Indiana University East

EA802 Whitewater Hall
Replace Operable Windows and Interior Renovation
IU#20240646

ADDENDUM NO. 1

22 October 2025

2 FIRST FLOOR ENLARGED STAIR PLAN
1/4" = 1'-0"

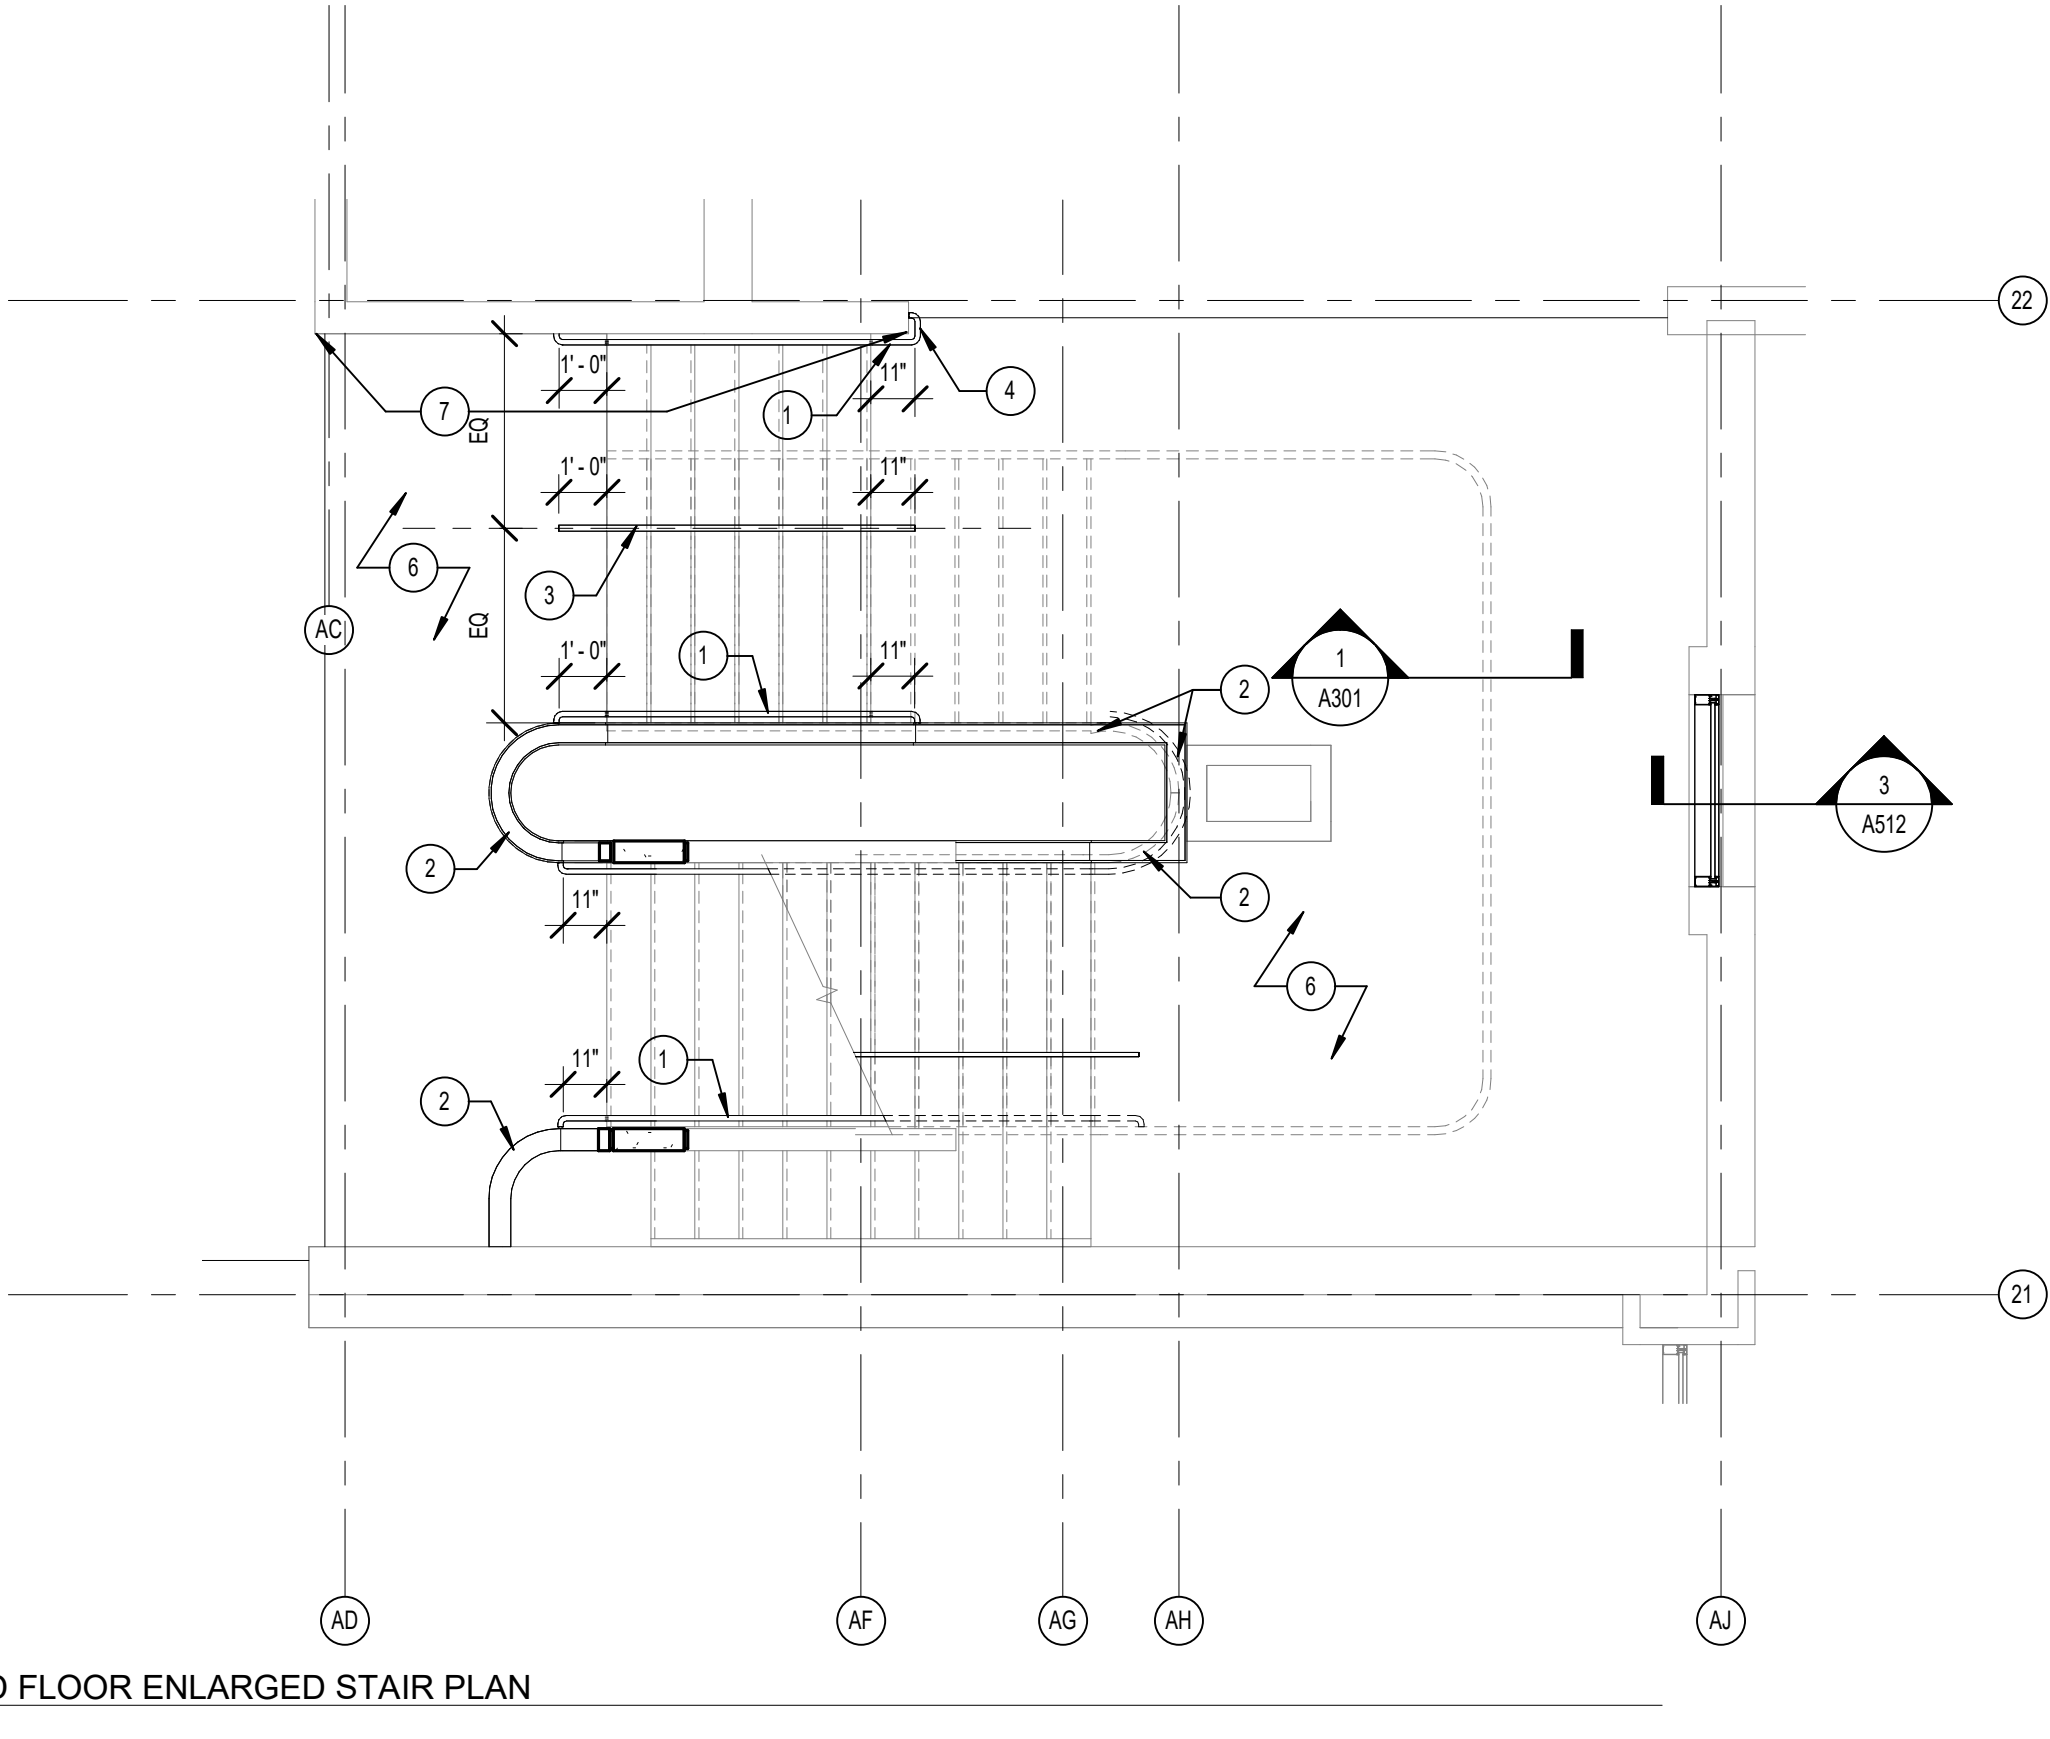
Q. There is a second intermediate handrail that I do not see on the plans. See 2/A301. Will this be included as Note 3 on A301?

1. Sheet A301 – Enlarged Stair Plans – Alternate 4
 - a. Revise First Floor Enlarged Stair Plan A301_2 to add the intermediate handrail, as shown on attached sheet.

A. Yes, the second intermediate handrail is to be included. See attached revised sheet A301.

1 GUARDRAIL SECTION
1" = 1'-0"

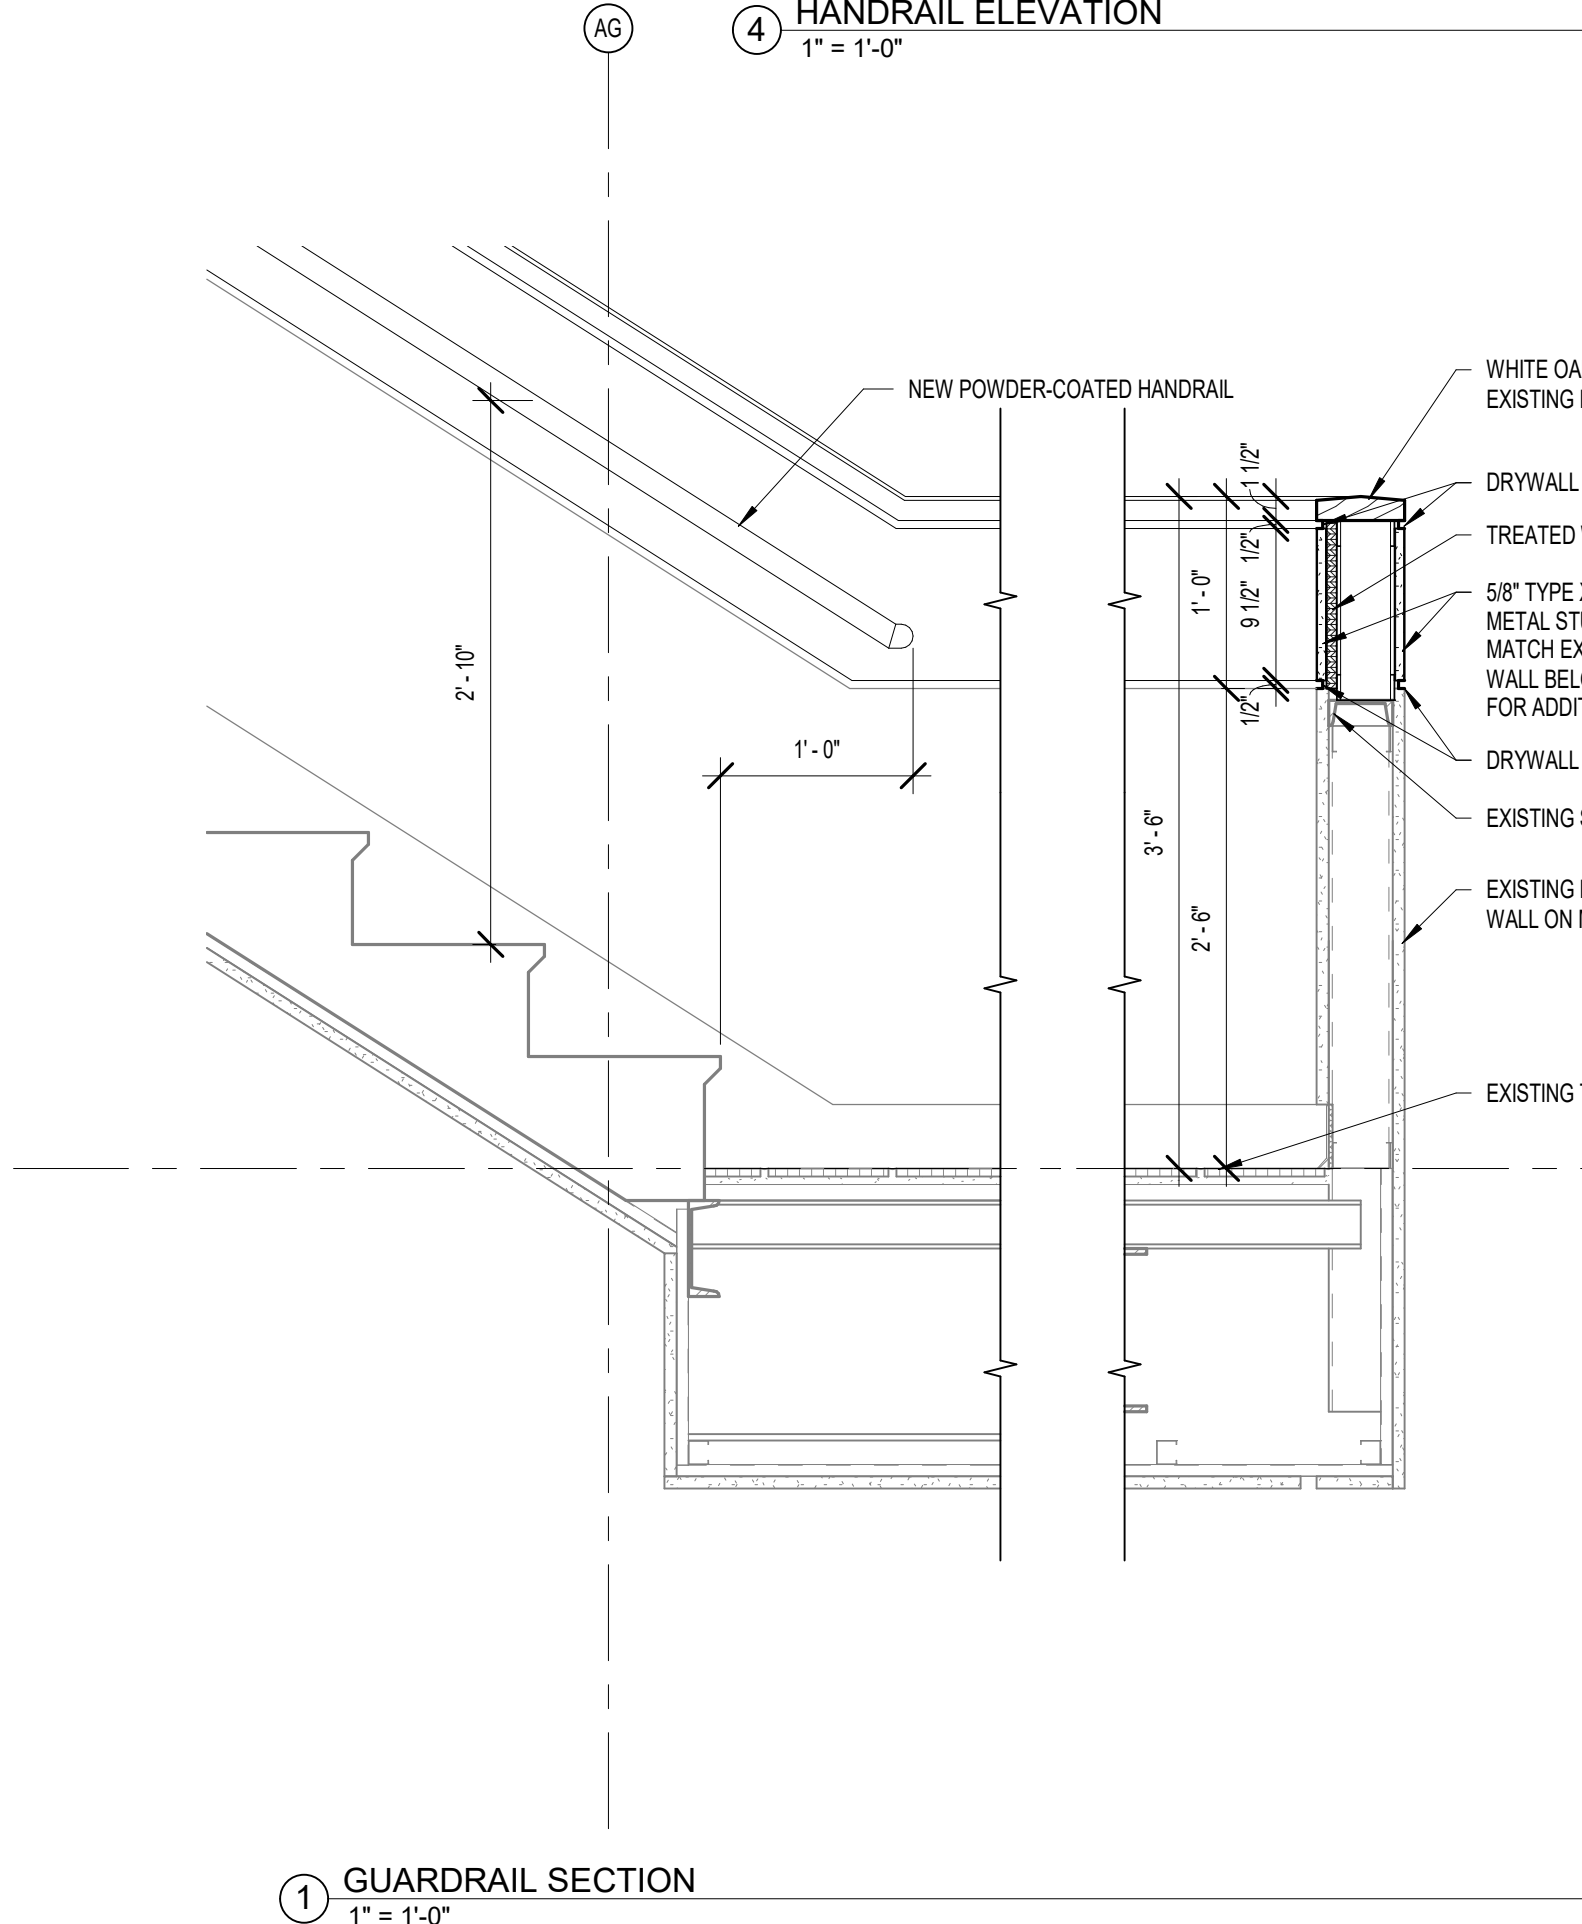
Q. What is the thickness of the white oak wall cap 2"?

Q. Are lath and plaster required to be used on the stair wall height extension?

Q. Is the wood cap on the stair wall required to be quartersawn?

Q. Confirm that the radius reveals are to be aluminum Fry Reglet.

Q. Fry Reglet cannot fabricate radius trims under 24" radius. All of the radiuses are under 24".

A. 1-1/2", see Detail A301_1.

A. No, lath and plaster are not required to be used. Gypsum wall board, per the Project Manual, may be used for the stair wall height extension.

A. This will need to be reviewed in the field with a physical sample, by the Owner and Architect.

A. A half inch reveal is to be provided between the existing stair wall and the new stair wall extension. The reveal may be the listed Fry Reglet reveal or similar.

A. A half inch reveal is to be provided between the existing stair wall and the new stair wall extension. The reveal may be the listed Fry Reglet reveal or similar.

4 HANDRAIL ELEVATION
1" = 1'-0"

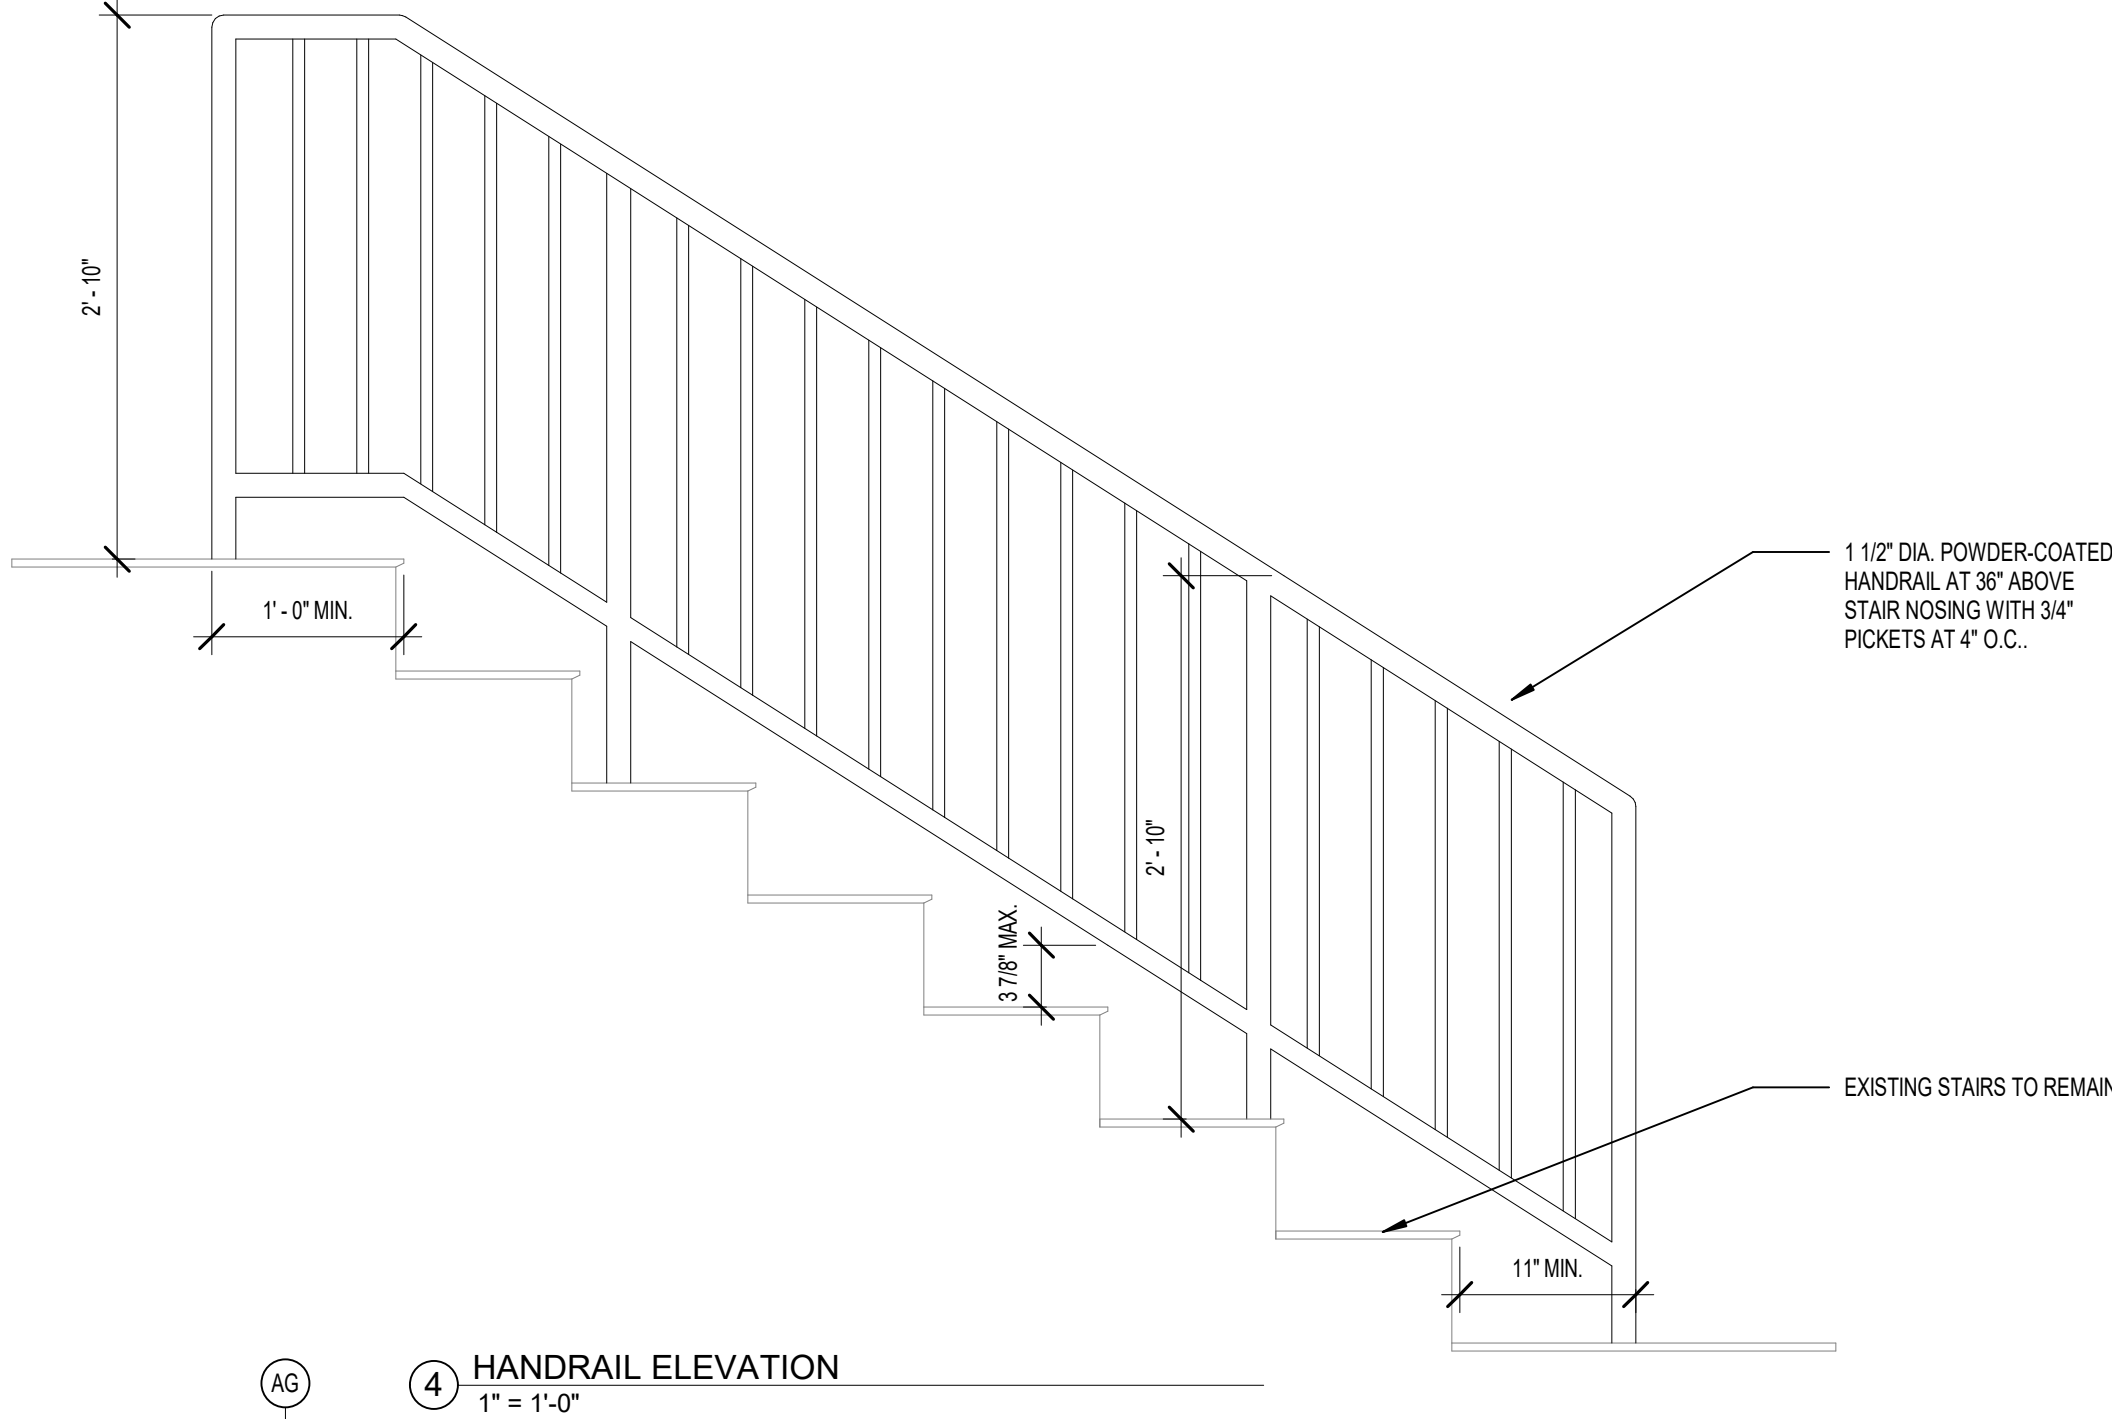
Q. Is tube steel required at the radius sections?

A. Handrail diameter is to be consistent along the full length of the handrail. Handrail diameter and height are to meet ADA requirements and lateral forces per IBC.
